### **IN THE DRAWINGS**

### **REMARKS**

Fig. 7

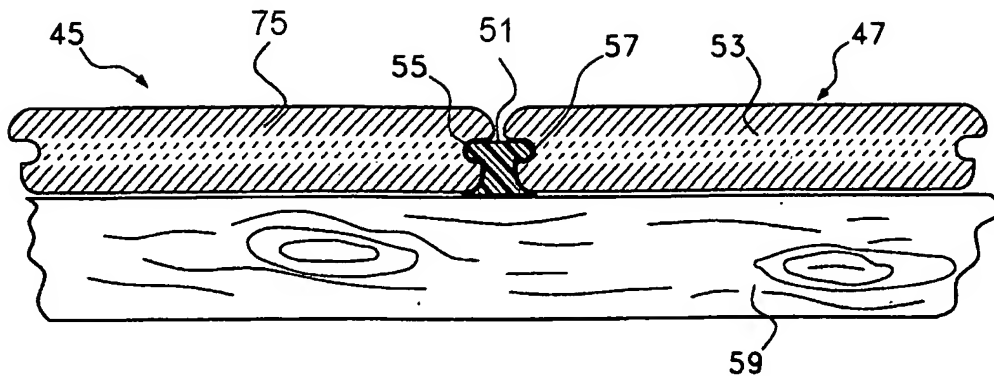
The drawings filed on May 24, 2005, were submitted in response to an objection lodged in the Final Rejection dated December 29, 2004, wherein the Examiner objected to the hatching used for element 51 of Fig. 7 in the version of the drawings submitted on September 12, 2003. In particular, the Examiner stated that the form of

hatching used for element 51 was incorrect for a plastic item. Accordingly, a new drawing sheet 2/2 comprising Fig. 7 was submitted, wherein the hatching of element 51 comported with the form for plastic delineated by the illustration in MPEP 608.02 (IX).

In the present Office Action, the Examiner has raised a different objection, indicating that the use of cross-section hatching may be misleading when compared with the statement in the specification that characterizes Figs. 7 and 8 as “end views.”

A further objection to Fig. 7 was raised, based on the presence of two instances of reference numeral "57." The Examiner has interpreted numeral 57 as referring to both a slot and a horizontal beam. The latter instance is submitted to be an obvious typographical error and has been corrected to be numeral 51. Attention is respectfully drawn to the specification at page 31, line 16 et seq., wherein Fig. 7 is described. Reference numeral 51 is identified at page 32, line 1, as referring to the end view 51 of horizontal beam 45. Reference numeral 57 is identified at page 32, line 9, as referring to a slot of beam 47. It is respectfully submitted that any ambiguity in the duplicate use of number 57 in Fig. 7 is thereby resolved.

For the sake of clarity, the specification has been amended in the Brief Description of the Drawings at page to recite Figs. 7 and 8 as being cross-sectional, end views.

Applicant respectfully submits that a skilled artisan would recognize that a decking system, such as that represented in Fig. 7, is typically constructed using a plurality of deck boards, such as boards 53 and 57, disposed horizontally onto a plurality of supporting boards, such as joist 59. As a result, the artisan would recognize that the configuration shown in Fig. 7 could well be depicted either as a strict end view or as a cross sectional view taken at any plane perpendicular the long axis of the deck boards anywhere along their length, and looking from the end view. Applicant respectfully draws attention to the version of Fig. 7 submitted with the original filing of January 3, 2002, which included hatching of boards 53 and 57 and anchoring element 51, as well as the side-grain depiction of wooden joist 59, as evidencing intent that Fig. 7 be regarded as showing elements 51, 53, and 57 in cross-sectional view. Still further, the original specification refers to the end view of “cut wood” of decking boards

(beams) 45 and 47. *See* page 32, lines 1 and 9. Applicant thus maintains that the skilled artisan would recognize the propriety of using cross-sectional hatching of the decking boards 45 and 47 and the anchoring element 1 of Fig. 7 and the board 45 of Fig. 8.

In view of the amendment of the description of Figs. 7 and 8 in the specification, the amendment of Fig. 7, and the foregoing remarks, applicant maintains that any ambiguity between the depiction of Figs. 7 and 8 and the description of those figures in the specification, including the Brief Description of the Drawings, has been obviated. The correction of a duplication in use of numeral 57 in Fig. 7 has also been effected.

For clarity of the record, applicant further notes that in the intermediate version of Fig. 7 submitted September 12, 2003, the anchoring device was erroneously labeled as element "51." The version of Fig. 7 submitted May 24, 2005 restored reference numeral "1" to refer to the anchoring device, in conformity with the labeling given in Fig. 7 as originally filed.

For reference, a copy of Figure 10 of the British patent, including markings added by the Examiner, is reproduced below.

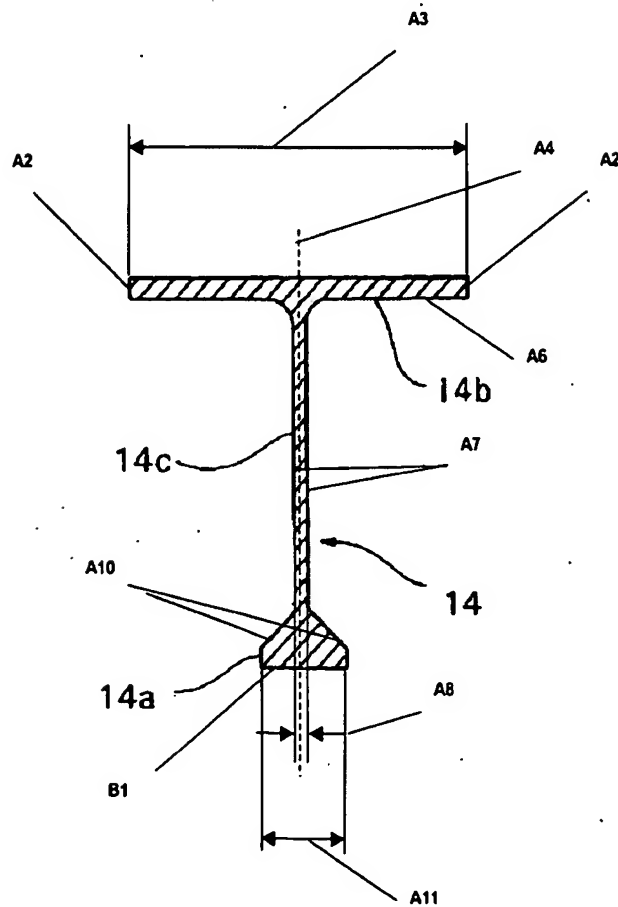
**Regarding claim 29, the British patent discloses, in Figure 10, an anchoring device consisting essentially of a substantially flat horizontal top element A10, at least one substantially vertical support member A20, and a substantially flat horizontal bottom element A30. The top element A10 has a top view configuration including two sides A2 and a predetermined first width A3 as measured side to side. The first width A3 is measured at a maximum width between the sides A2. The top element A10 has an imaginary center line A4. The support member A20 is attached to an underside A6 of the top element A10 along the center line A4<sup>1</sup> and the support member A20 extends downwardly therefrom. The support member A20 has two sides A7 and a predetermined second width A8 as measured side to side at a maximum width. The bottom element A30 has a flat bottom view configuration, which includes sides A31 and having a generally trapezoidal shape, and a predetermined third width A11 as measured side to side at a maximum width at a trapezoidal base B1. The first width A3 is greater than the second width A8 and the third width A11. The third width A11 is greater than the second width A8. The device is made of molded plastic material (column 4, lines 72-84).**

Applicant respectfully traverses the Examiner’s contention that the British patent discloses every structural feature of the anchoring device delineated by claim 29, as would be required for a proper rejection under 35 USC §102(b).

above, the allegedly anticipatory article of the British patent, e.g. as depicted by Fig. 10 thereof, is specifically denominated a “preformed grouting strip.” The function of this strip is said to be spacing the tiles apart by a predetermined distance. See col. 2, lines 46-50. There is no disclosure or suggestion that the strip plays any role in anchoring the ceramic tiles with which it is associated to a wall or floor surface, or even that the grouting strip could be used in such a manner, on which the Examiner could reasonably assert that any “anchoring device,” let alone applicant’s particular device, is disclosed. Instead, that anchoring function is provided by a fixative disposed between the back surface of the tiles and the surface (e.g. wall or subfloor) to which the tile is applied.

feature corresponding to the receiving slots delineated by claims 29 and 33. Page 2, col. 1, lines 11-13 and 40-43. Horizontal projections A2 of “top element” A10 are not received in any slot. Instead, element A10 is installed with its horizontal projection A2 underneath the back surface of each tile, and with the plain edge of each tile abutting sections A7 and A31 on each side of grouting strip 19.

(Chen et al., US Patent 6,363,677, as annotated by the Examiner)

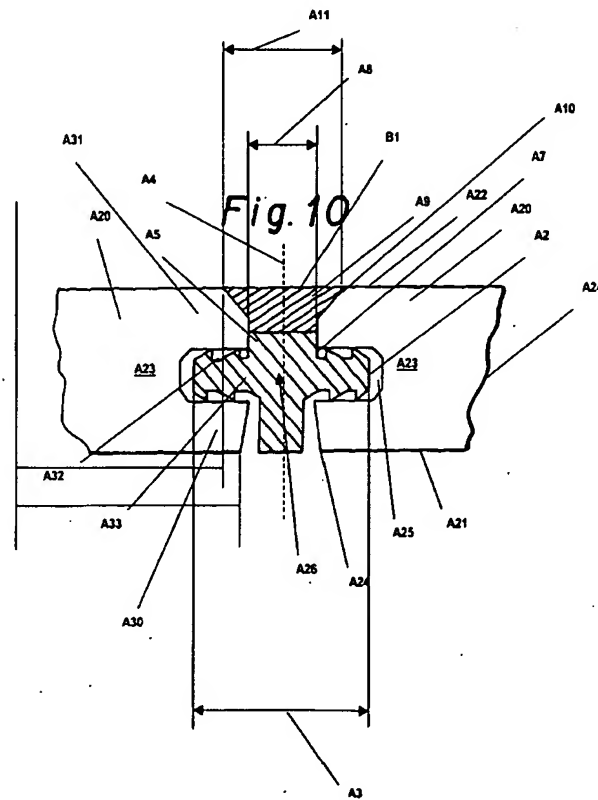
**Regarding claim 33, Chen discloses in Figure 5<sup>2</sup>, a decking system comprising boards A20 and an anchoring device A26. Each of the boards A20 has a top A21, a bottom A22, two sides A23 and two ends A24. At least one groove A25 is located along one of the sides A23. The anchoring device A26 consists essentially of a substantially flat horizontal top element A1,<sup>3</sup> at least one substantially vertical support member A5, and a substantially flat horizontal bottom element A9. The top element A1 has a top view configuration including two sides A2 and a predetermined first width A3 as measured side to side. The first width A3 is measured at a maximum width between the sides A2. The top element A1 has an imaginary center line A4. The support member A5 is attached to an underside A6 of the top element A1 along the center line A4 and the support member A5 extends downwardly therefrom. The support member A5 has two sides A7 and a predetermined second width A8 as measured side to side at a maximum width. The bottom element A9 has a flat bottom view configuration, which includes sides A10, and having a generally trapezoidal shape, and a predetermined third width A11 as measured side to side at a maximum width at a trapezoidal base B1. The first width A3 is greater than the second width A8 and the third width A11. The third width A11 is greater than the second width A8. The device is made of molded plastic material capable of having a metal fastener driven through (col. 7, lines 56-60).**

<sup>2</sup> *Sic* – the Examiner's annotations, including reference number designations, were made with specific reference to Fig. 10, not Fig. 5.

Significantly, the Examiner has not pointed to any single, unitary structure that embodies the anchoring device included in the system of claim 33. Rather, the Examiner apparently has alleged that the combination of elements designated as first and second spline sections 54, 56 in Figs. 4(a) and 5(a) of Chen et al. constitutes such an anchoring device. As disclosed at col. 3, line 66 to col. 4, line 2, and confirmed by Figs. 5(a) and 10, these sections are clearly separate items, pictorially differentiated in the figures by distinct hatching. Importantly, second spline section 56 is usable independent of first section 54, e.g. in the Fig. 5(b) configuration. It is submitted that the Chen et al. disclosure that spline sections 54 and 56 optionally be joined (*see* col. 6, lines 49-56) alone distinguishes applicant's anchoring device, which is taught as being "made of molded plastic material," inherently rendering it of unitary construction.

The confusion arising from the Examiner’s inversion of the supposed Chen anchoring device is even further compounded by the Examiner’s characterization of the sides A2 as defining a width A3 of what he purports to be the top element A1 [*sic*]. On the other hand, claim 33 calls for an anchoring device having a “substantially

flat horizontal top element having a top view configuration which includes two sides...” (emphasis added). Applicant respectfully submits that the allegedly anticipatory structure does not have the substantially flat horizontal top view configuration delineated by claim 33. Instead, the portion of element 54 that extends downward from the projections received in board grooves A25 in the depiction of annotated Fig. 10 (the “top” of the Chen et al. structure as apparently understood by the Examiner<sup>4</sup>) precludes the Examiner’s conclusion, because it establishes a surface of element “A1” that is not substantially flat horizontally.
